HISTORIC AND DESIGN REVIEW COMMISSION

HDRC CASE NO: 2015-330
ADDRESS: 633 S ST MARYS
LEGAL DESCRIPTION: NCB 179 BLK LOT 19 (UNIVISION REDEVELOPMENT SUBD) 2014-NEW ACCT PER SPLIT PER PLAT 9658/137-142 FILED 9/5/2013
ZONING: D RIO-3
CITY COUNCIL DIST.: 1
APPLICANT: Nic Whittaker
OWNER: CRP-GREP Elan Riverwalk Owner LP
TYPE OF WORK: Signage
REQUEST:

Historic and Design Review Commission
Design Review Committee
Report & Recommendation

Agave Project Identification

Sign in Context - *Nighttime*

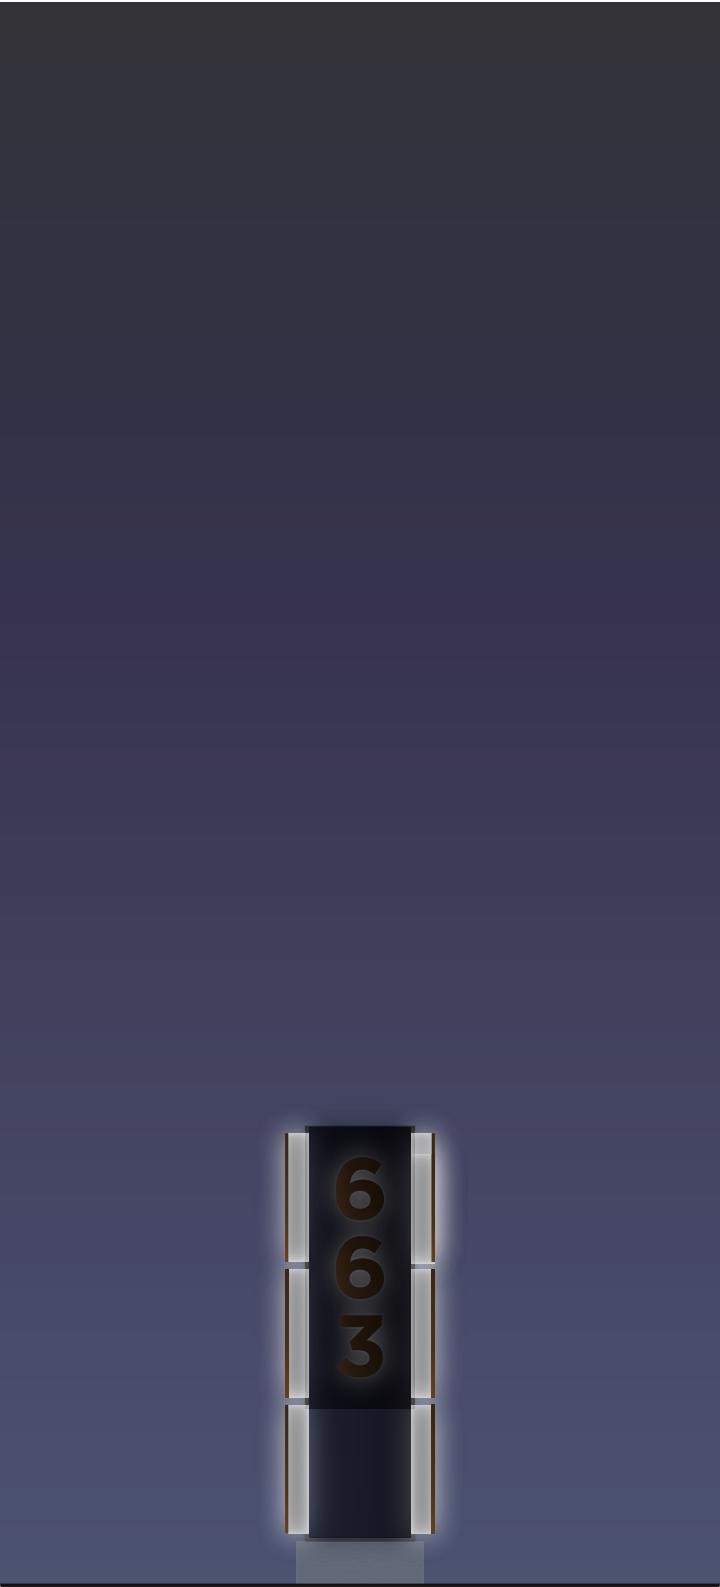
COMMENTS/CONCERNS: MG: QUESTIONS REGARDING MONUMENT SIGN'S

LETTERING AND MATERIALS. QUESTIONS REGARDING CORNER DETAILING

AND STACKED. TC: LIGHTING SHOULD NOT PRODUCE AN INTERNALLY

ILLUMINATED SOURCE / EFFECT.

the letters will be solid with the light coming
from behind

PAGE TITLE / ELEMENT TYPE
Sign Type 100C: Site Identification
Riverwalk

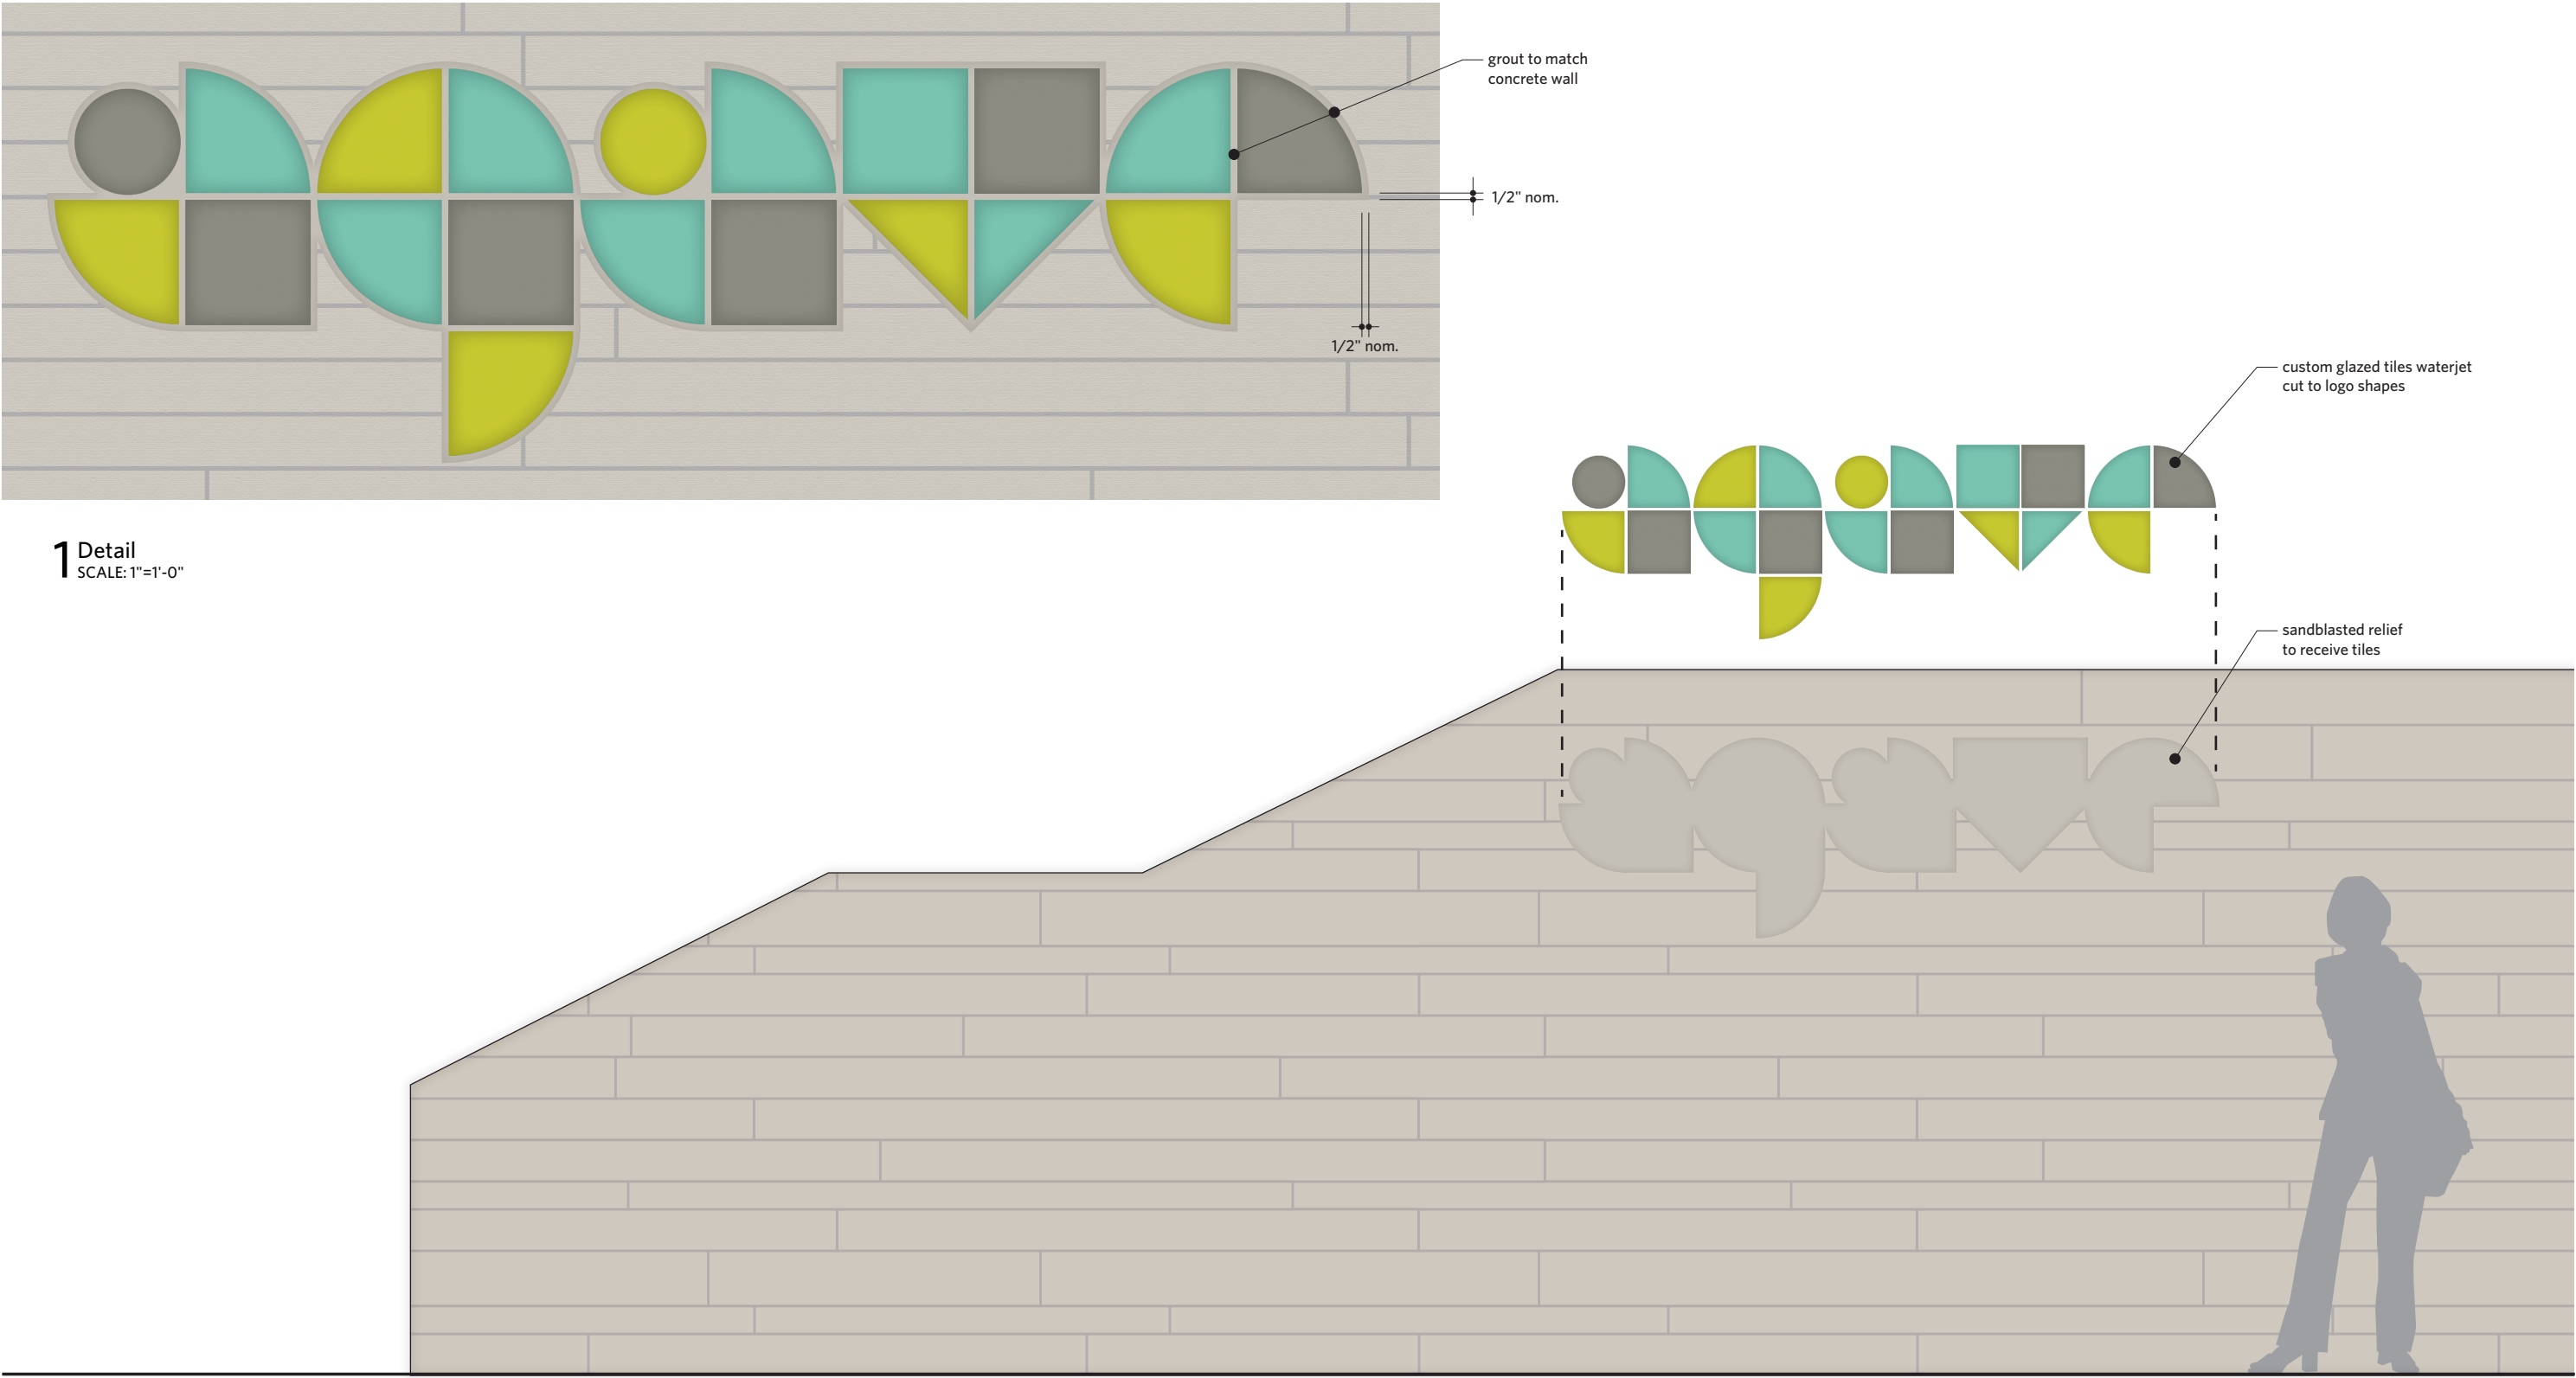
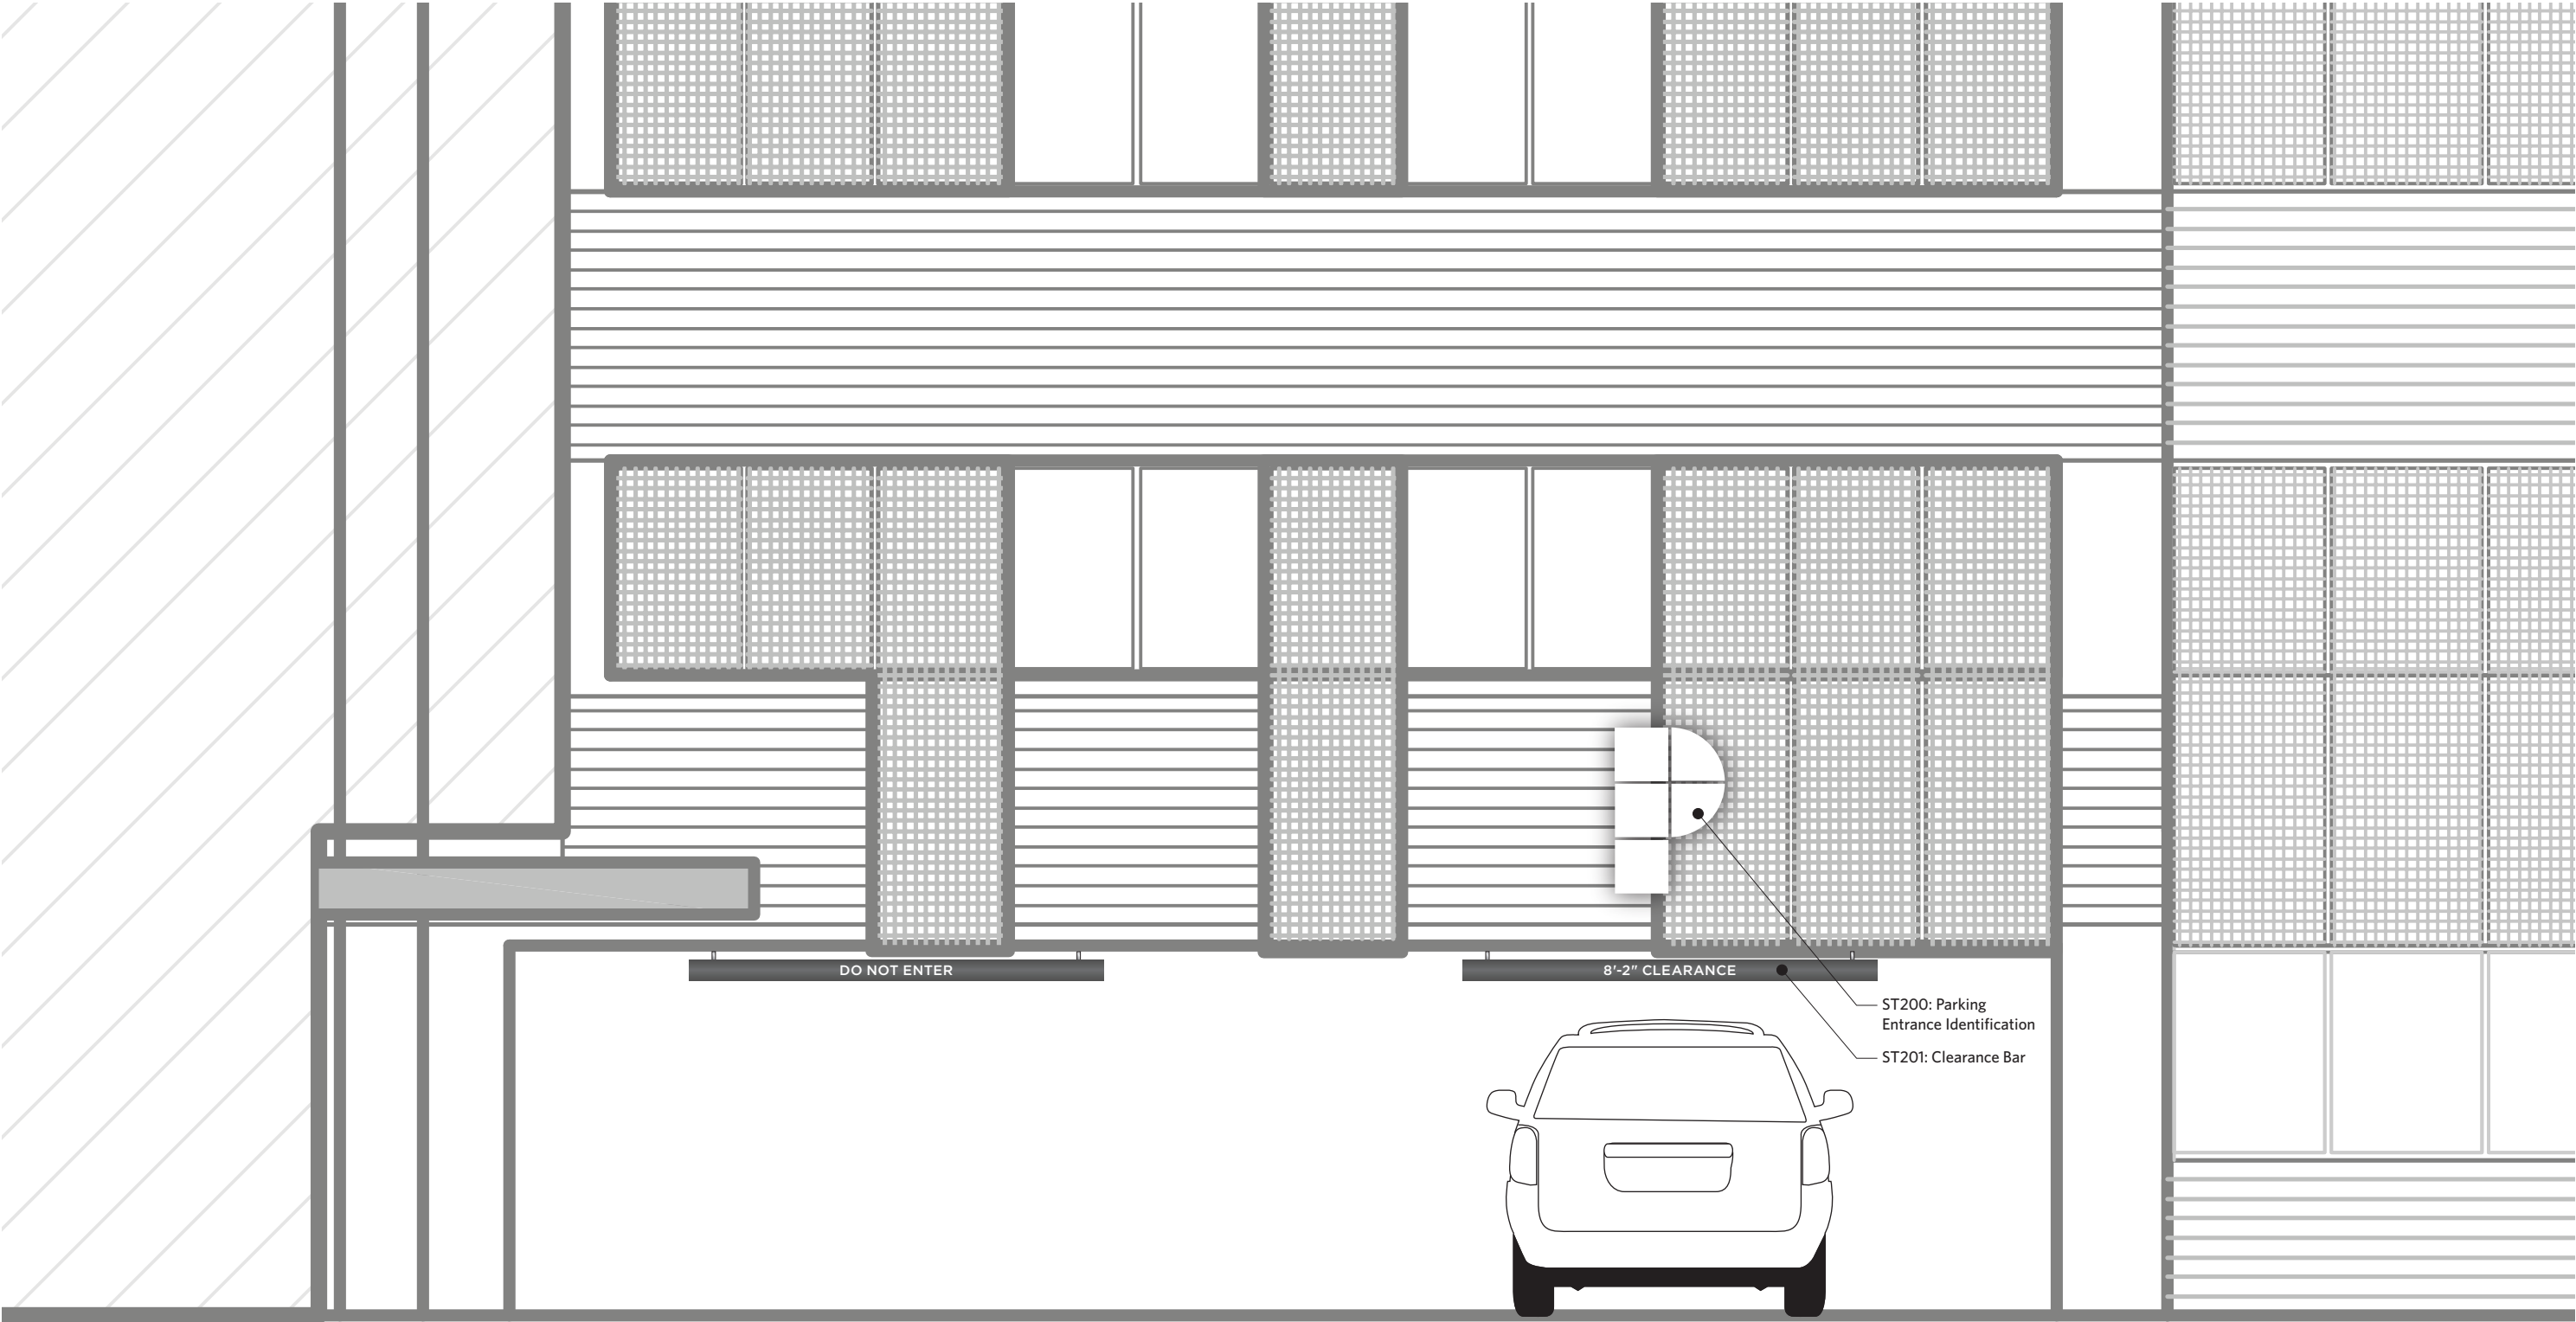
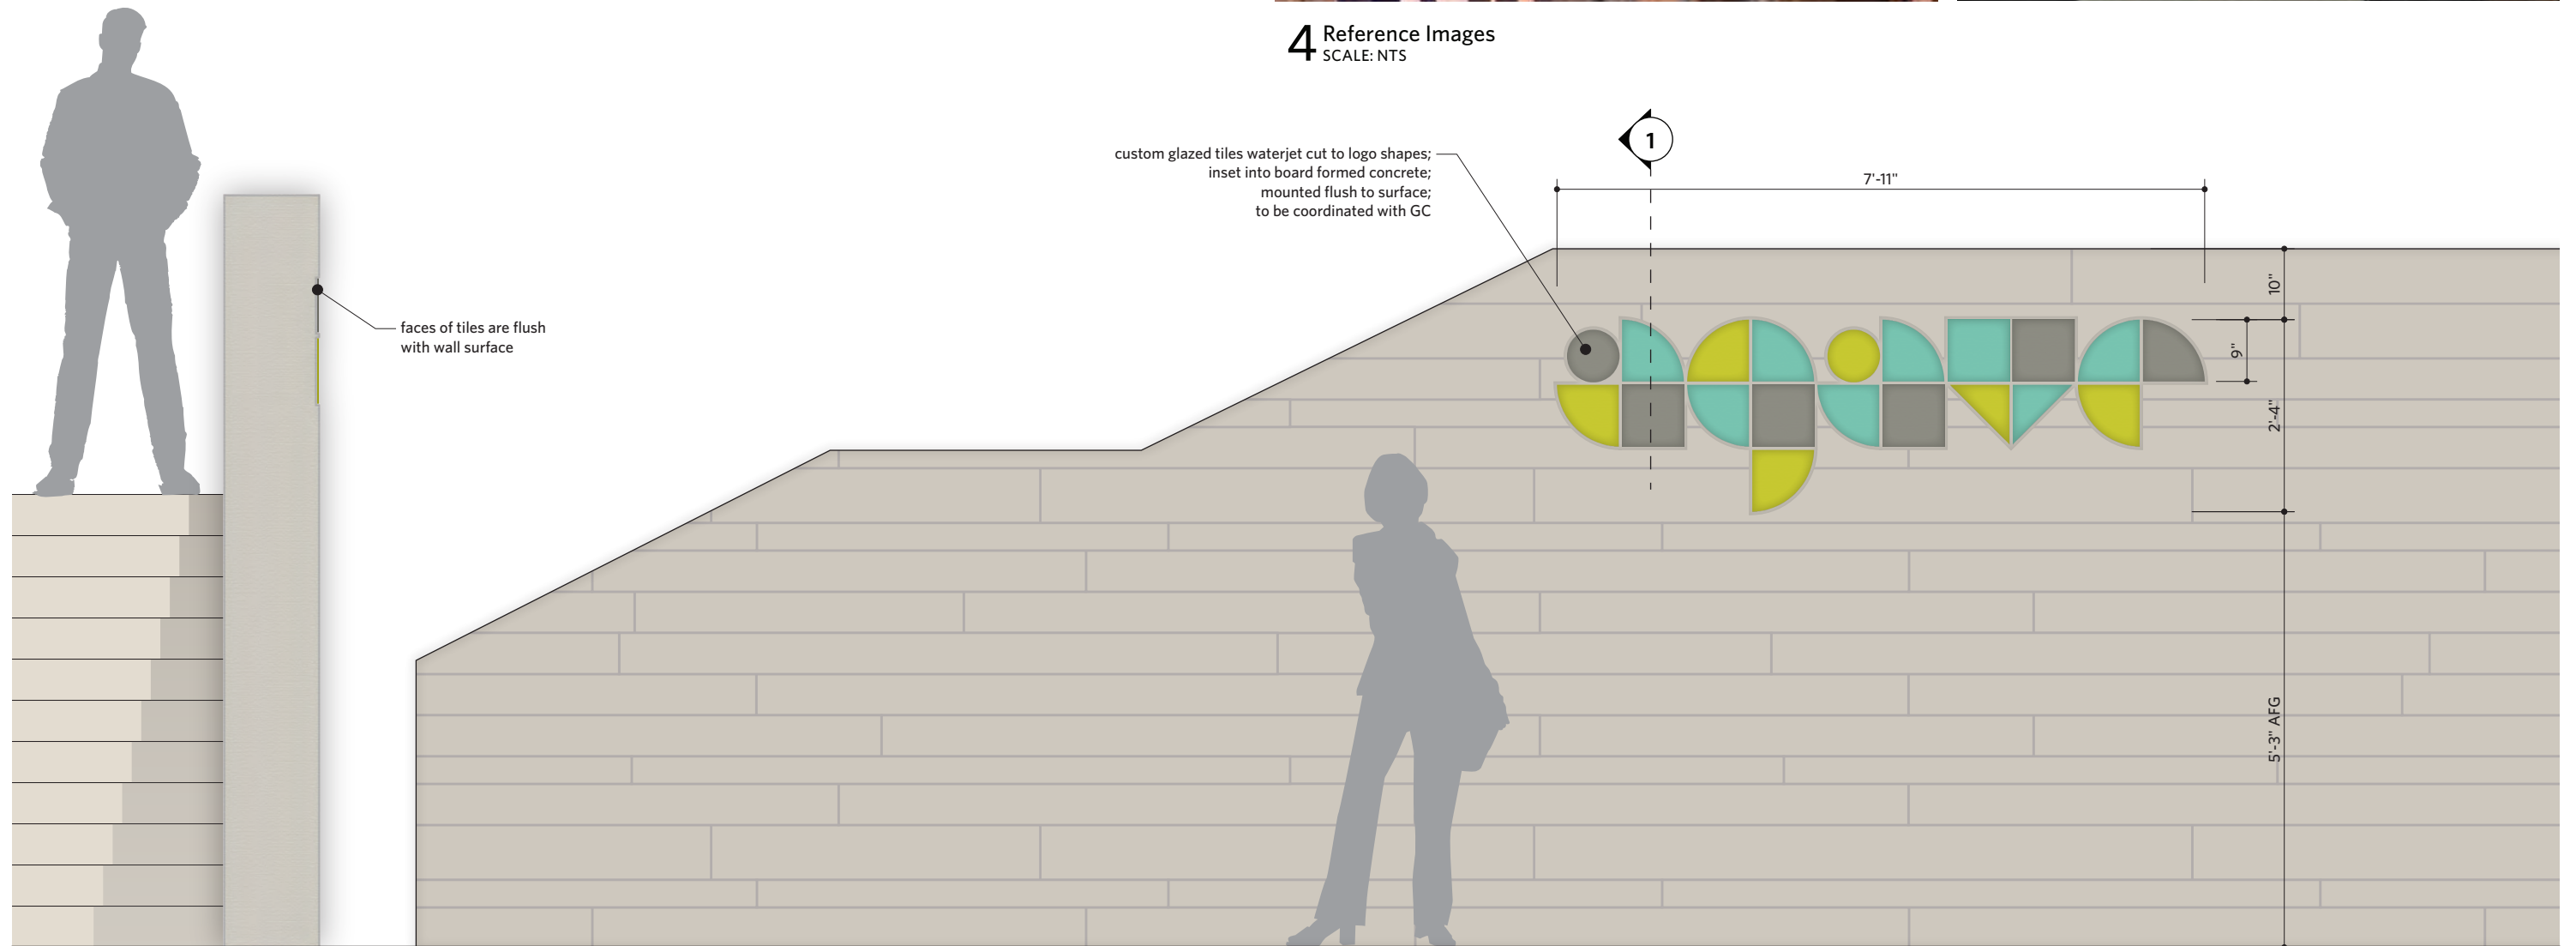
- d. At the Riverwalk level, the applicant has proposed to install a wall sign to be mounted flush within the existing wall surface at the Riverwalk Level. The sign is to be 7' – 11" in length, 2' – 4" in height totaling approximately 20 square feet in size. This signage is to read "AGAVE". The sign will be constructed of custom glazed waterjet cut tiles inserted into board formed concrete to be flush with the surface of the wall. The applicant has not proposed for this signage to be lit. Per the UDC Section 35-681(c)(2), signs at the Riverwalk level must not be larger than 8 square feet. Staff recommends that the applicant reduce the size of this proposed signage to no more than 8 square feet. The applicant has not proposed for this signage to be lit.

- i. That the applicant reduce the proposed Riverwalk level signage to no more than 8 square feet.
